Global MX-5 Cup Car Technical Service Bulletin #02-18-2019

Optional: Global MX-5 Cup - New Battery Tender battery and corresponding tray

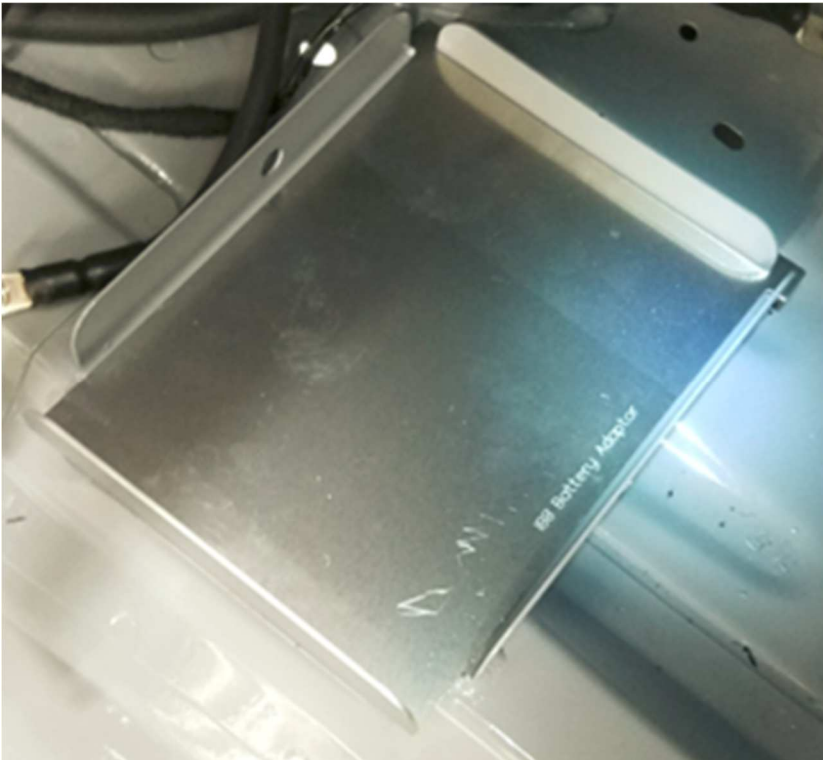
1. Remove Battery Cables from Battery and Remove Battery from Battery Tray. You May Discard Old Battery Capture
2. Hammer The Inside Flange of the Battery Box Flat, or Grind/Cut the Flange off
